CITY OF CODY  
PLANNING, ZONING AND ADJUSTMENT BOARD  
TUESDAY JUNE 14, 2022  
CITY HALL COUNCIL CHAMBERS @ 12:00 NOON

<b>MEETING DATE:</b>	JUNE 14, 2022	<b>TYPE OF ACTION NEEDED</b>	
<b>AGENDA ITEM:</b>		P&Z BOARD APPROVAL:	X
<b>SUBJECT:</b>	ARCHITECTURAL REVIEW FOR MODIFICATION TO 1239 AND 1243 RUMSEY AVENUE. SPR 2022-12	RECOMMENDATION TO COUNCIL:	
<b>PREPARED BY:</b>	TODD STOWELL, CITY PLANNER	DISCUSSION ONLY:

<b>MEETING DATE:</b>	JUNE 14, 2022	<b>TYPE OF ACTION NEEDED</b>	
<b>AGENDA ITEM:</b>		P&Z BOARD APPROVAL:	X
<b>SUBJECT:</b>	SITE PLAN REVIEW: YELLOWSTONE REGIONAL AIRPORT TERMINAL EXPANSION. SPR 2022-14	RECOMMENDATION TO COUNCIL:	
<b>PREPARED BY:</b>	TODD STOWELL, CITY PLANNER	DISCUSSION ONLY:

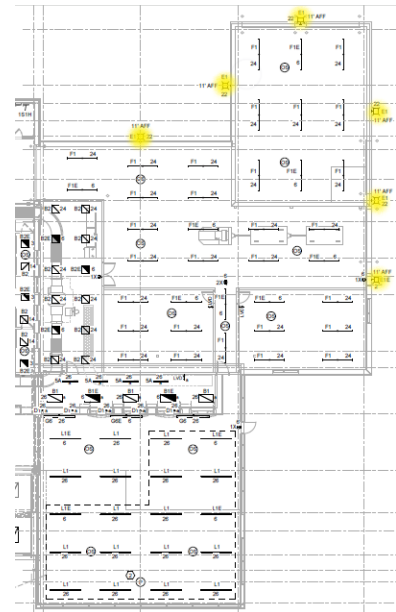
Exterior lighting is proposed in the form of six, full-cutoff LED wall packs with a color temperature of 4,000K. The spacing and lighting levels are appropriate. The wall packs are on the masonry portion of the building, as depicted by the yellow highlights on the lighting diagram to the right.

CODY	YELLOWSTONE REGIONAL AIRPORT EXPAND AND REHABILITATE COMMERCIAL TERMINAL AIP 3-56-0006-044-2022/WYDOT NO. ACO012D, ACO025	WYOMING	PROJECT NUMBER 2414-250-026 SHEET NUMBER 7 DRAWING NUMBER C003
UTILITY PLAN

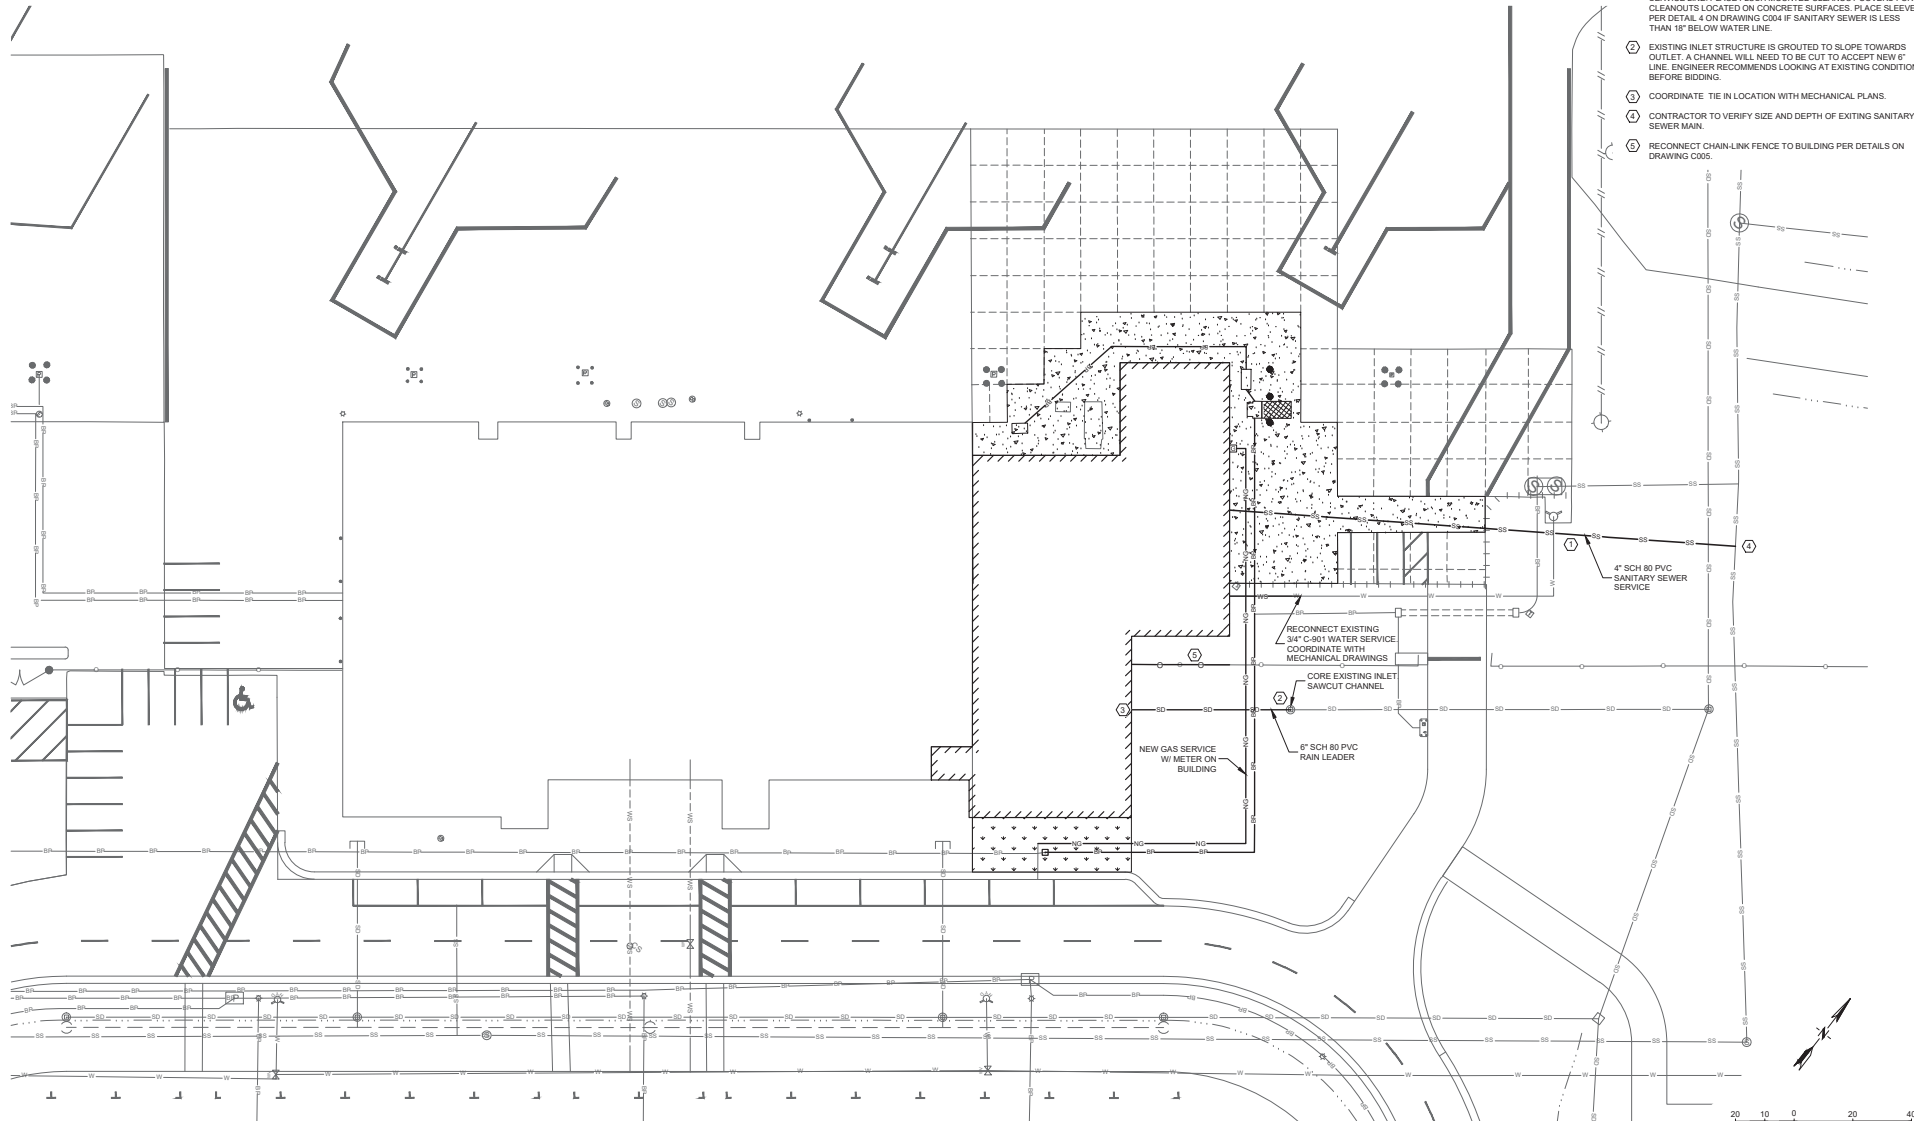
Due to a short review period on this file, not all utility providers have submitted comments on this proposal yet. To planning staff, the utility site plan appears generally acceptable for what is shown. See Sheet C003 and ED100. Planning staff did not see in the plans how some of the 3<sup>rd</sup> party utilities will be relocated—specifically TCT and either Spectrum or CenturyLink.

The sewer service line is not required to be Schedule 80 PVC (Schedule 40 is typical, and other options are allowed under the plumbing code.) Also, cleanouts in the sewer service line are noted at 50 feet maximum—plumbing code allows up to 100 feet of developed pipe length, so realize there is some flexibility in the plumbing code to go

YELLOWSTONE REGIONAL AIRPORT EXPAND AND REHABILITATE COMMERCIAL TERMINAL		WYOMING		PROJECT NUMBER 2444-005-026
ELECTRICAL SITE DEMO PLAN				SHEET NUMBER ---
				DRAWING NUMBER ED100

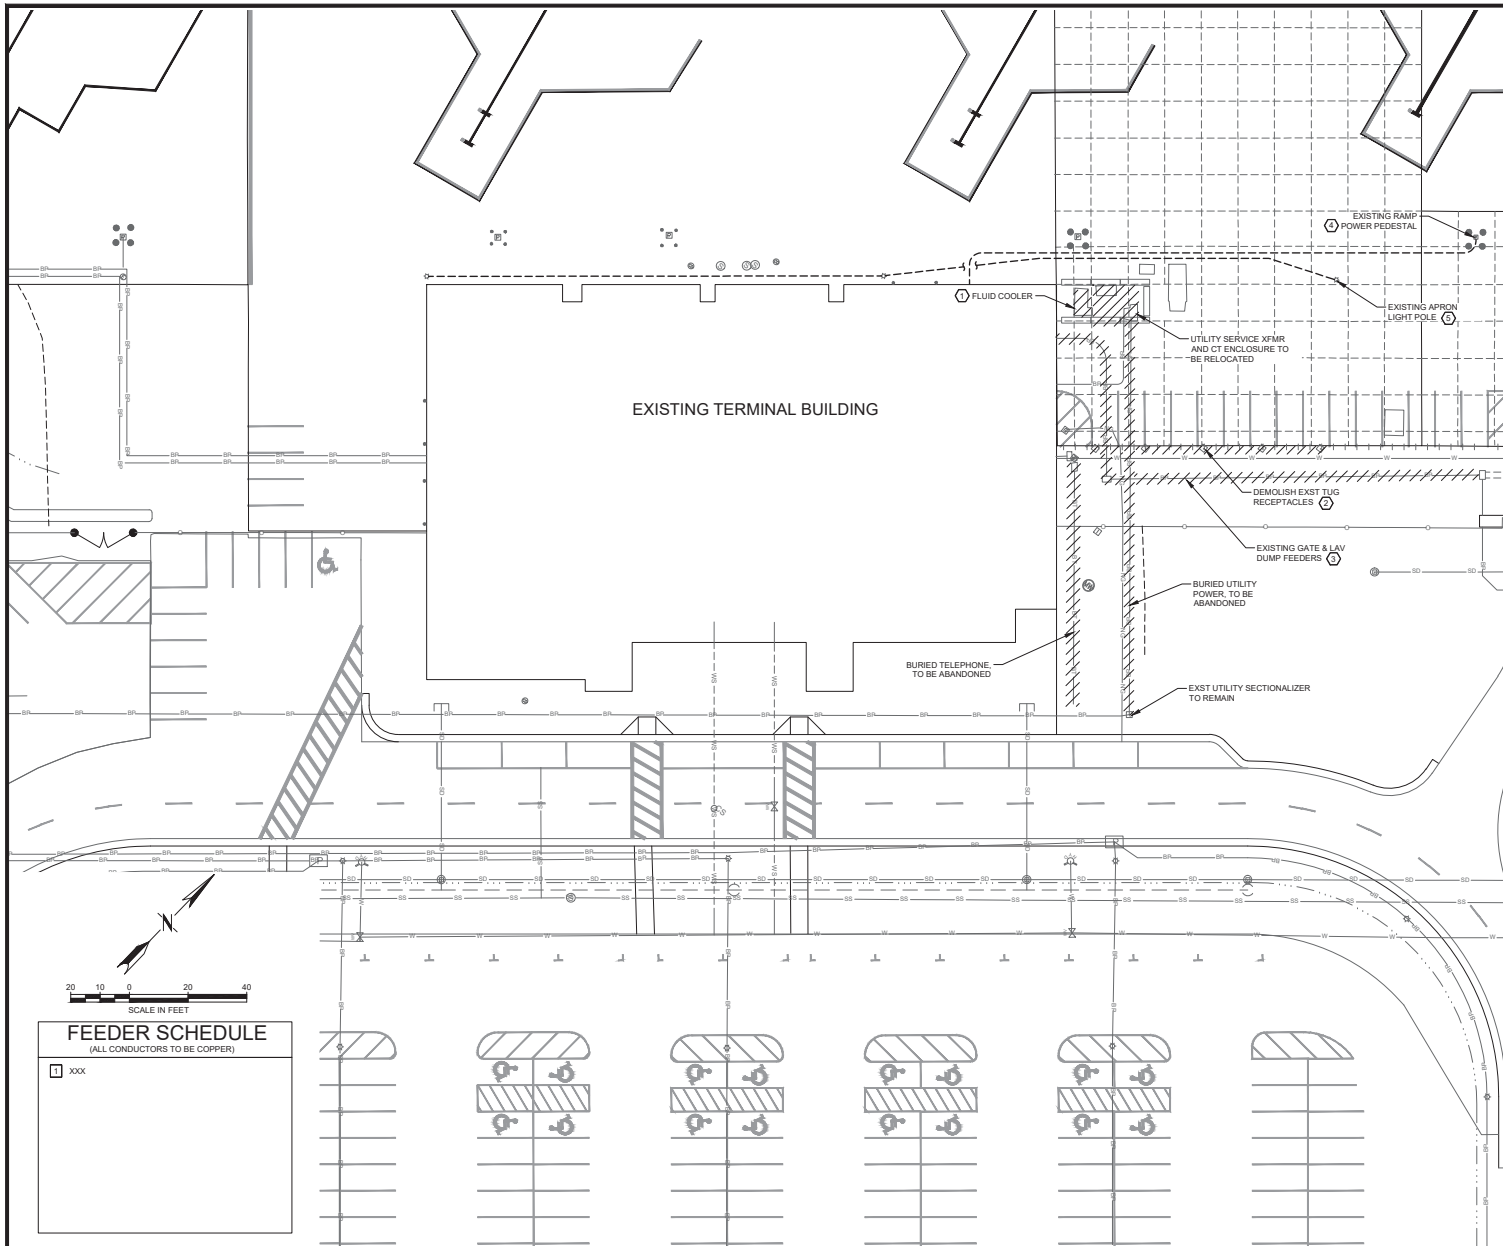
The specifics of the electrical work (relocation of transformer and sizing for addition) are still under review at the time of this staff report.
